# Access Compliance Report

## Public Rights-of-Way

### (Curb Ramps)

Intersection ID: 10035790	Main Street: REMOUNT_RD	Cross Street: N/A	Location:	N
ADA ID: CBD9F9BC1780	Ramp Type: Perp	Initial Pass/Fail: Fail	Overall Compliance: No	Severity Score: 13.75
Codes/Mitigation Info/Possible Solution		Field Measurements/Component Compliance

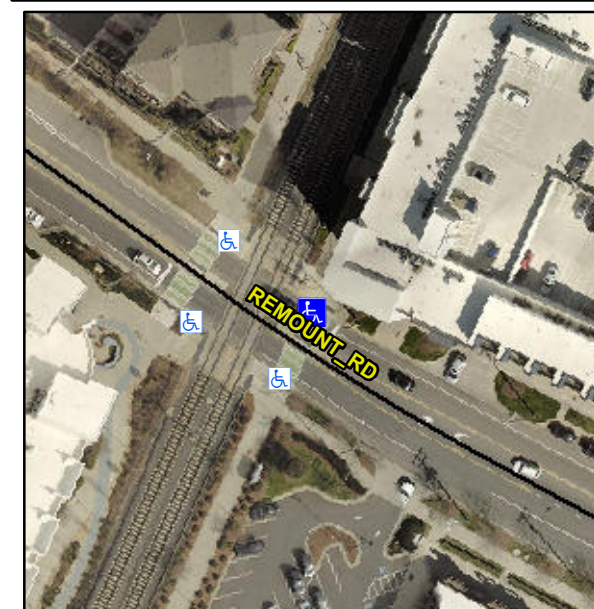
**R304.2.2**

Compliance	Description	Data	Compliance	Description	Data
N/A	Ramp Length (in)	103.0	No	Ramp Slope (%)	8.6
Yes	Ramp Width (in)	144.0	Yes	Ramp XSlope (%)	2.8
N/A	Flare Type LT	N/A	N/A	Flare Type RT	N/A
N/A	Flare Slope LT (%)	N/A	N/A	Flare Slope RT (%)	N/A
N/A	Flare Traversable LT?	N/A	N/A	Flare Traversable RT?	N/A
N/A	Landing Length (in)	N/A	N/A	DWS Provided?	N/A
N/A	Landing Width (in)	N/A	N/A	DWS Contrast?	N/A
N/A	Landing Slope (%)	N/A	N/A	DWS Length (in)	N/A
N/A	Landing X Slope (%)	N/A	N/A	DWS Full Width?	N/A
N/A	Landing Curb? (Y/N)	N/A	N/A	DWS Offset (in)	N/A
N/A	Shared Landing?	N/A			
N/A	Gutter Ponding?	N/A	N/A	Gutter Slope (%)	N/A
N/A	Gutter Lip Ht (in)	N/A	N/A	Gutter X Slope (%)	N/A
N/A	Painted X Walk1?	Yes	N/A	Painted X Walk2?	N/A
	X Walk 1 Direction	To SW		X Walk 2 Direction	N/A
N/A	X Walk 1 Width (in)	136.0	N/A	X Walk 2 Width (in)	N/A
	X Walk 1 Slope (%)	0.5		X Walk 2 Slope (%)	N/A
	X Walk 1 X Slope (%)	3.1		X Walk 2 X Slope (%)	N/A

**Remove & Replace Entire Ramp.**
